## **STAFF REPORT**

**To:** RVCA Executive Committee – Application Hearing  
**From:** Eric Lalande, MCIP, RPP, Senior Planner, Planning and Watershed Science  
**Subject:** Hearing of Application for Development – Ontario Regulation 174/06  
**Date:** February 8, 2024

**Application:** RV6-0622 and RV6-4723 (Violation)

### **Revised Application for Development:**

# TOPOGRAPHIC PLAN OF SURVEY OF

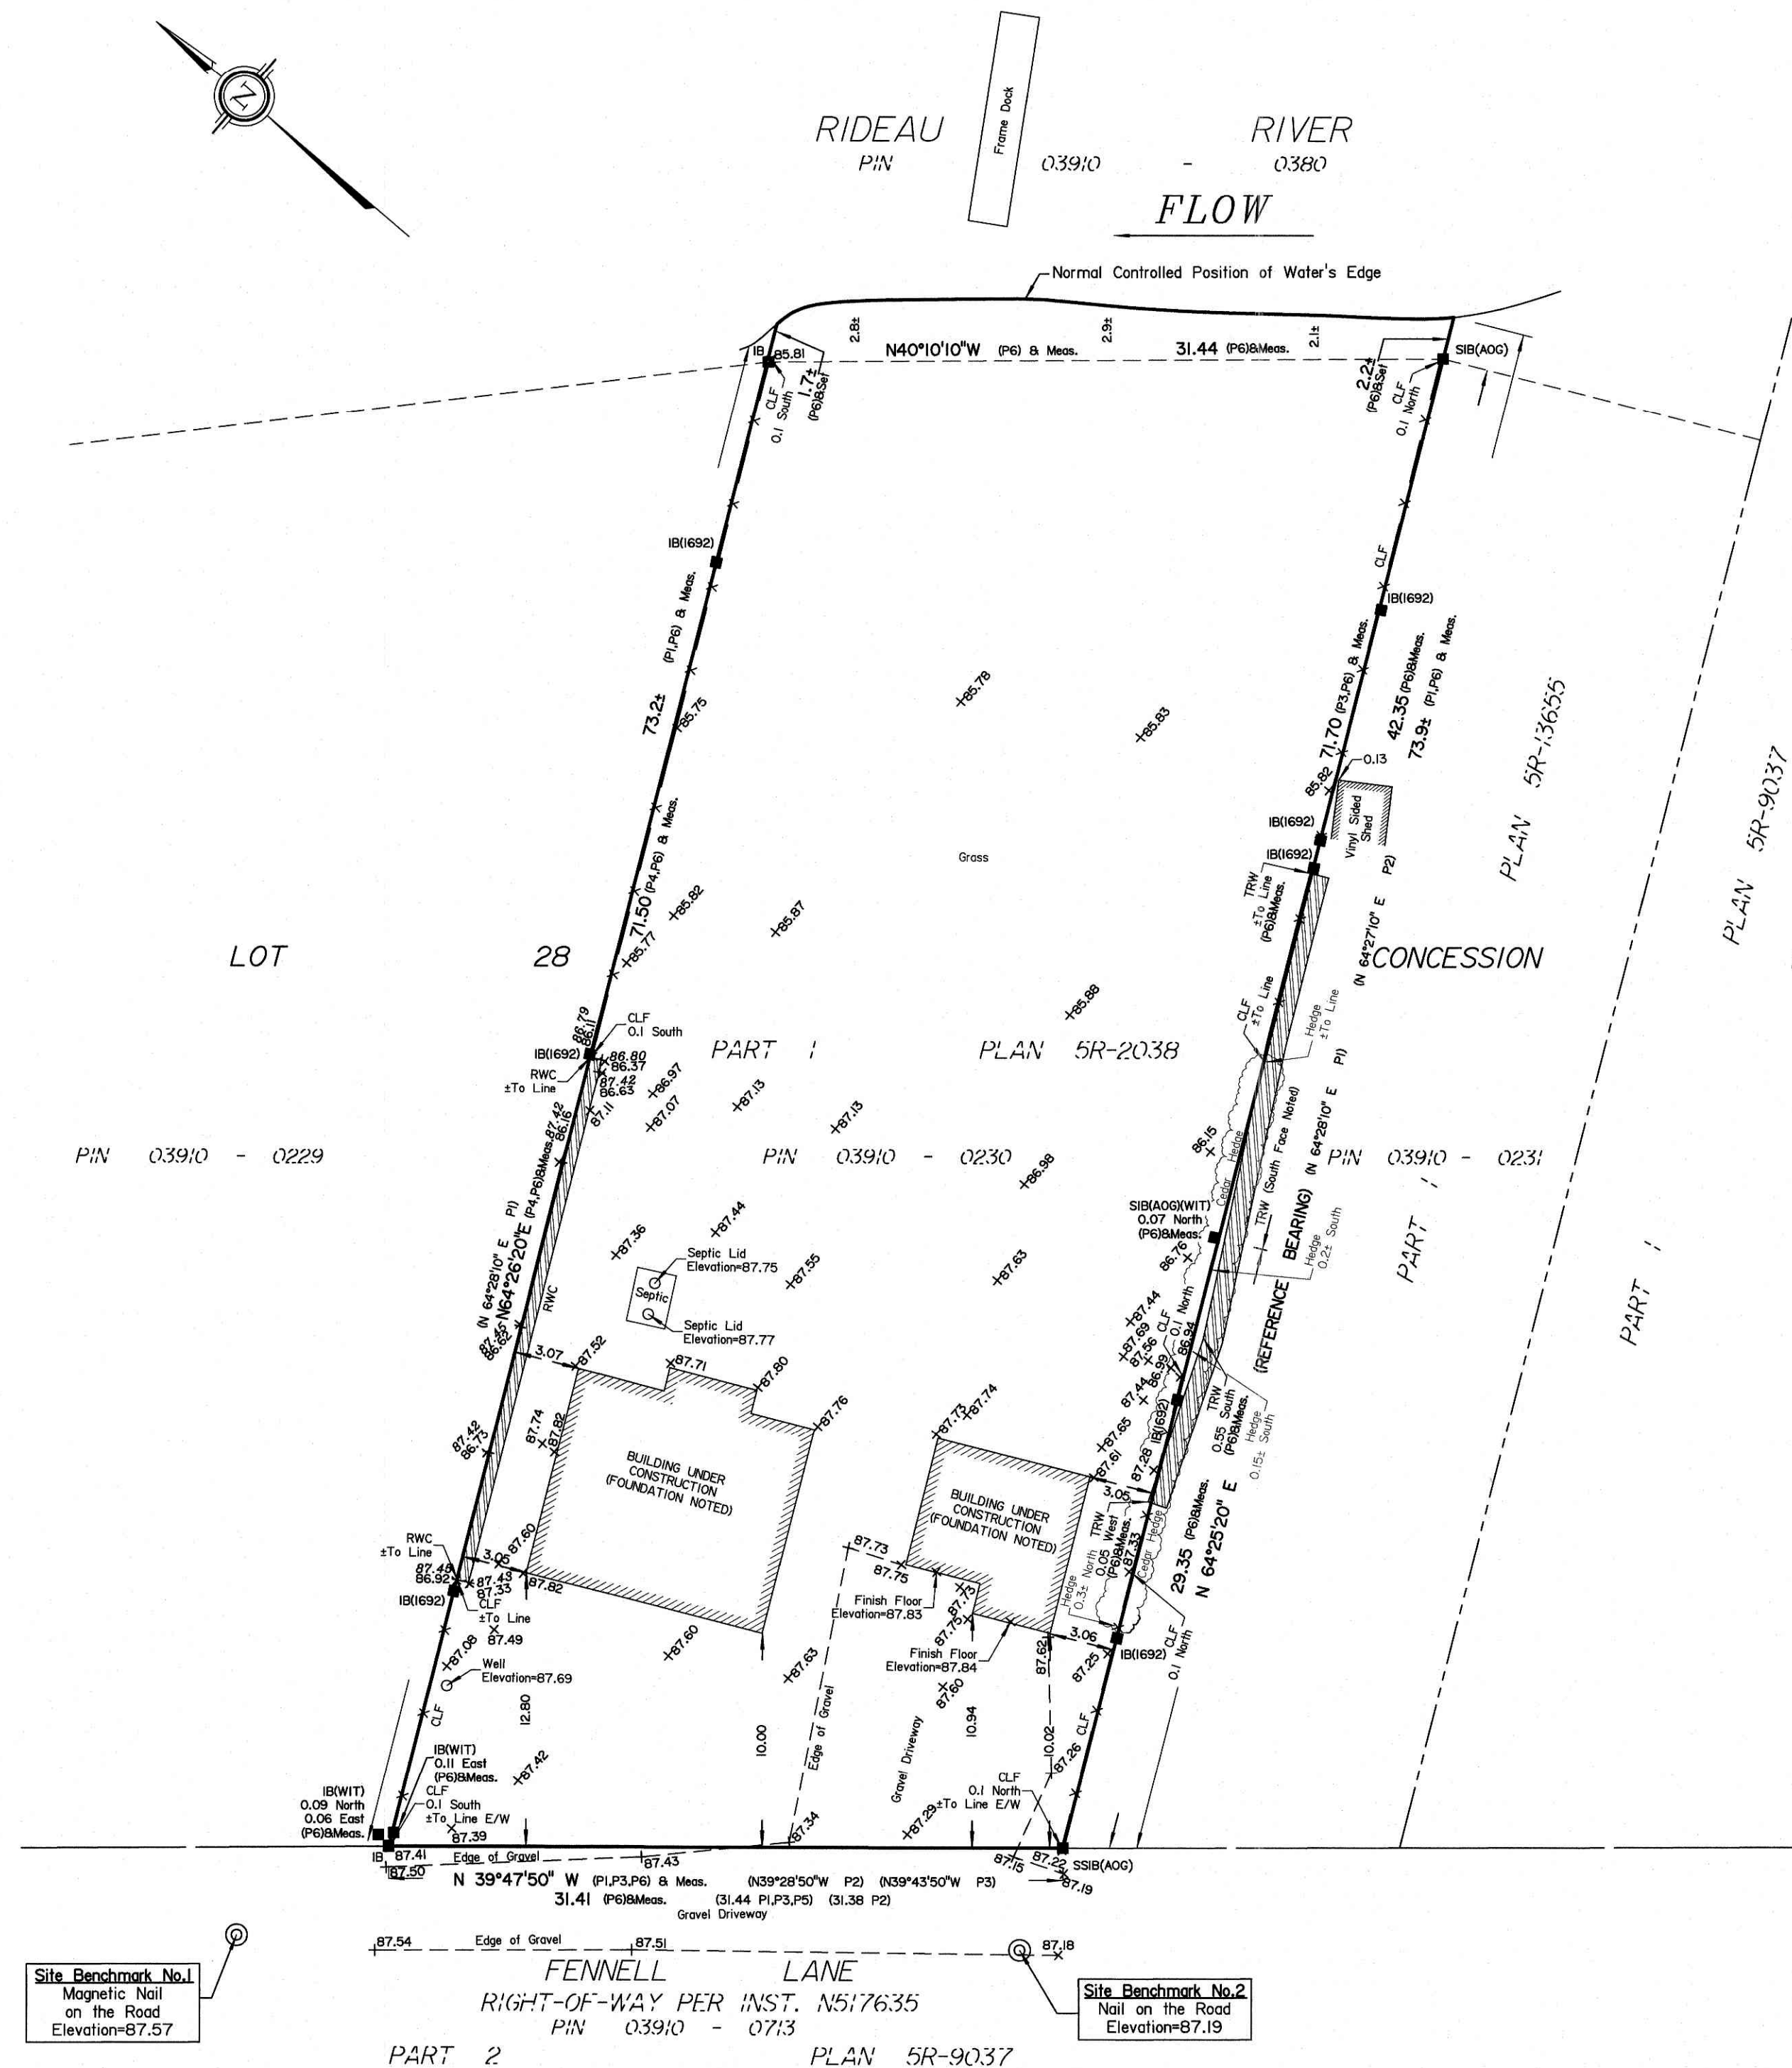
An unquantified volume of fill has been placed on the property in excess of the grading work as approved by the original application. While the original approved grading plan was prepared by a qualified professional, the requested changes to the grading have not, nor have they been presented or analysed in accordance with the above noted policies. Further, the fill being proposed does not provide for any offsetting removal of fill, and at depths greater than that provided by the policies. Therefore, it is apparent that the policies are unable to be met without significant changes to the design, and likely not achievable given the proposed development and location within the floodplain. As such, it has not been demonstrated that the work requested as part of the revised application will result in no negative impacts on the floodplain.

The submitted topographic survey provide updated grades that indicates that fill in the rear yard has been fill in depths up to approximately 1.6 metres in depth, varying depth as it ties in to existing grades. Further, the as-built grades are roughly 0.2 metres greater than approved at the tie-in to the dwelling. The topographic survey also suggests the top of floor of the garage is constructed 0.3 metres higher than proposed, which impacts the grade and volume required for access to the garage for vehicles. No elevation data was provided for the construction of the dwelling, which impacts the ability for staff to assess the floodproofing requirements noted above.

4. The proposed development has not demonstrated that the placement additional fill will not create adverse impacts associated with flooding.
5. Insufficient information is available for staff to make additional review to weigh the application fully against the RVCA's development policies.

- 3) **Placement of fill beyond the extent indicated in the Proposed Lot Grading Plan dated February 14, 2022.** The additional fill was required to blend the house, garage, septic and neighbouring property with a safe and maintainable slope to the existing grade. It was also used to provide for sustainable frost protection around the footings of the buildings rather than exclusively employing only insulated footings where the insulating material could experience degradation over time. The additional fill was also recognized as providing for a safe and secure passage from the residence and garage to the lower yard area fronting the Rideau River. The grade now also allows for safe passage of property maintenance equipment (ie: lawn tractor). The February 14, 2022 grading plan provided for a somewhat hazardous passage to the lower yard area/waterfront and indeed opened up possible liability issues for the homeowners should injury occur as a result of any possible visitors to the property transversing the grade and losing their footing.

RVCA advised that additional fill may introduce additional flooding on neighbouring properties should water levels ever reach that far. The additional fill however, similarly follows the grading permitted on adjacent properties so we don't understand the rationale as to why this would not also be permitted. Additionally, one neighbour has a "grandfathered" retaining wall that our fill reaches to partly at some points but does not come close to equaling or surpassing. As per RVCA instructions, we have commissioned and attached a new survey of the property showing the improved grading configuration.

As such, we seek RVCA approval to retain the fill currently in place. See attached photos and grading survey drawing.

1 PORCH PLAN  
D10 SCALE: 3/16"=1'-0"

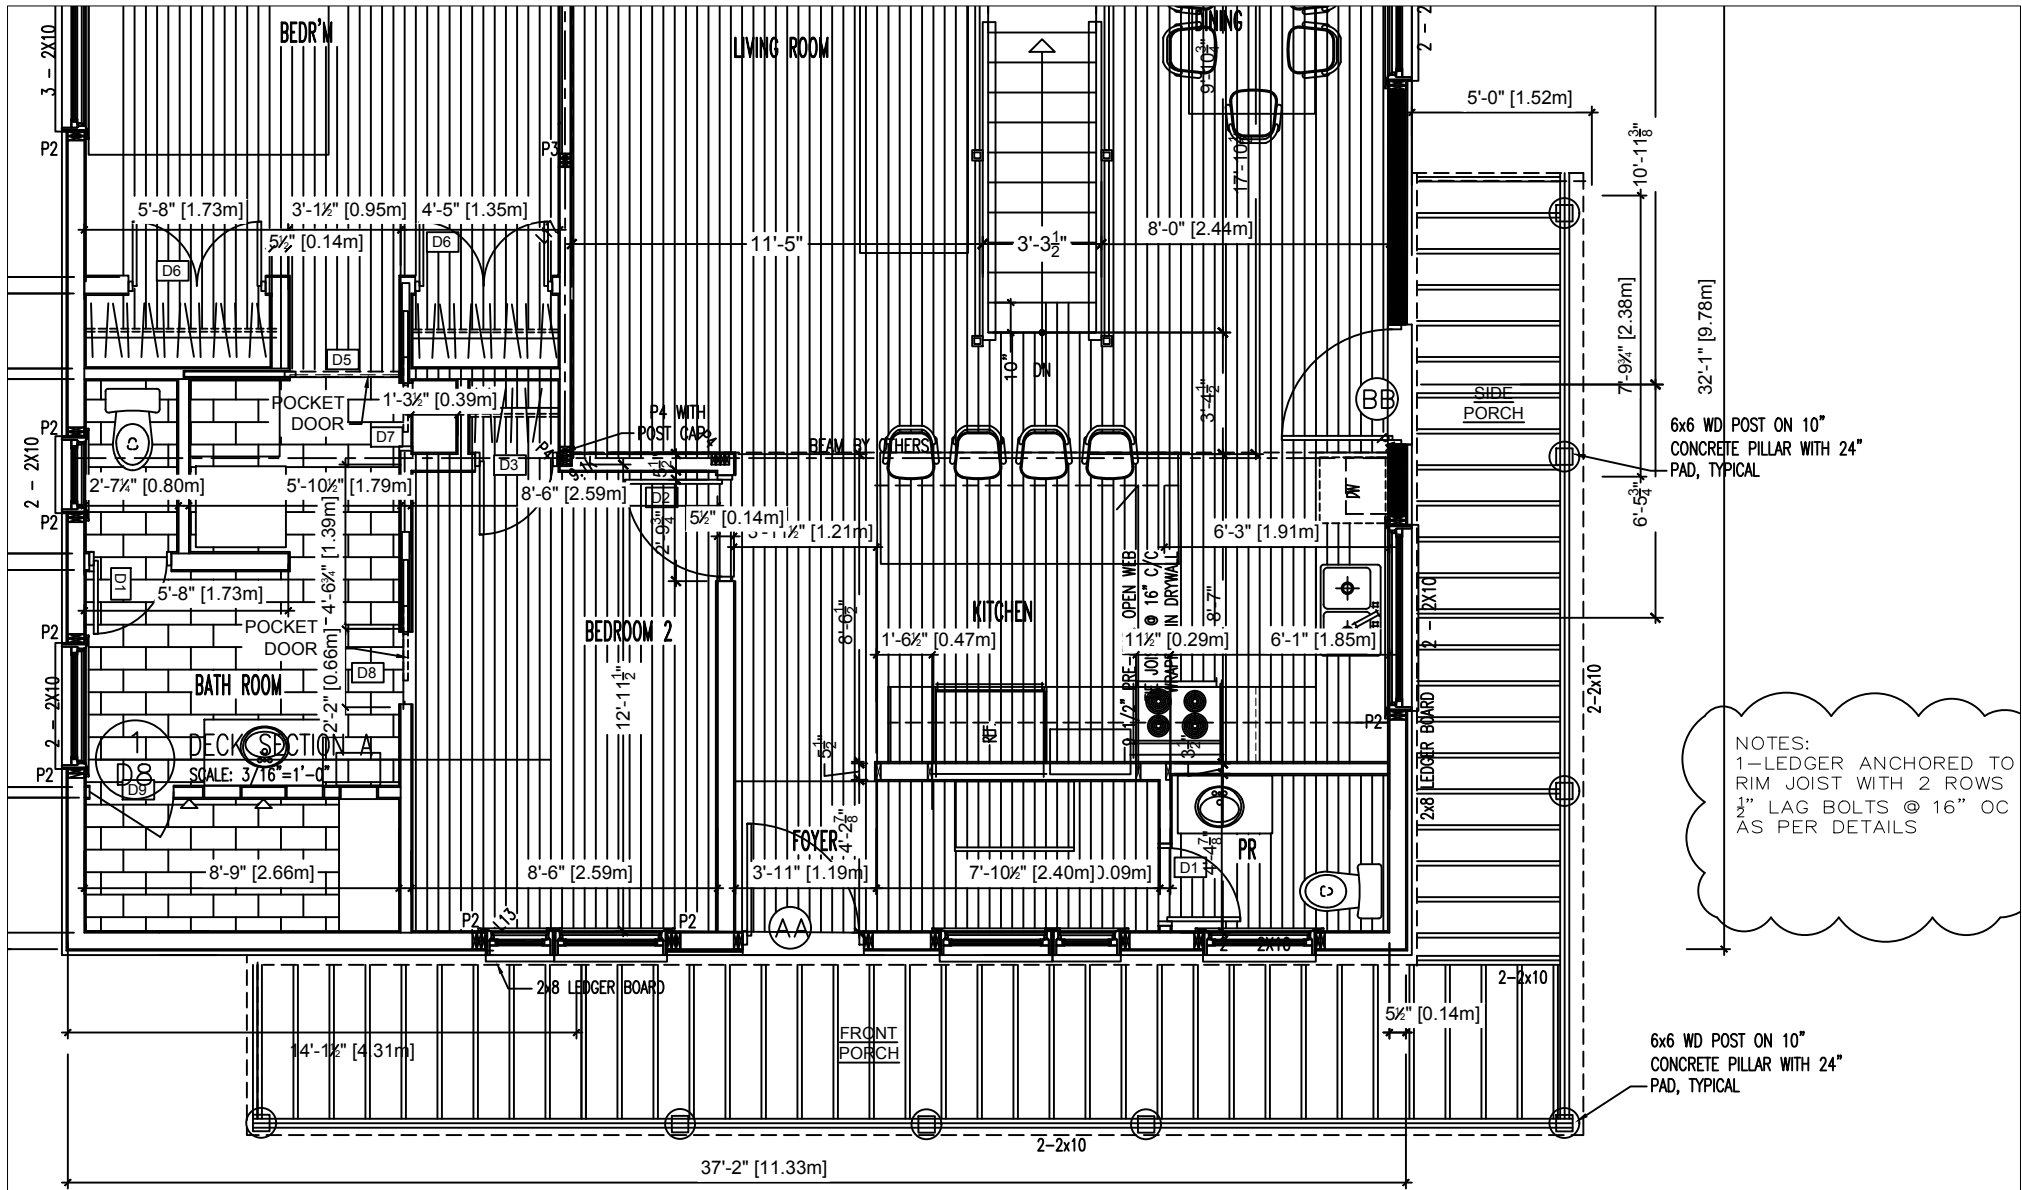
The covered porch is sized at approximately 27.13 m<sup>2</sup> which is greater than the maximum 20 m<sup>2</sup> permitted by size and it is entirely covered which exceed the coverage permitted by policies.

- 2) **Construction of a covered porch.** The wrap around porch roof was previously approved by the City as per stamped plans. Stamp date August 4, 2022. The porch decking follows the porch roofline to allow for use of the cover above. Without the porch decking, we are left with a sheltered area we cannot realistically make use of. We are retired and in our late sixties so it is very natural to desire to be able to enjoy the shelter provided by the porch roof. We picture sitting on it in the evening or morning to simply enjoy the rural nature of the setting. As such, we have plans to submit for a building permit to allow for use of this decking under such welcoming shade/shelter. It was advised however, that RVCA approval of this is required prior to the City providing building permit approval.

As such, we seek RVCA approval of the porch decking following the porch roofline. See attached plans and photos.
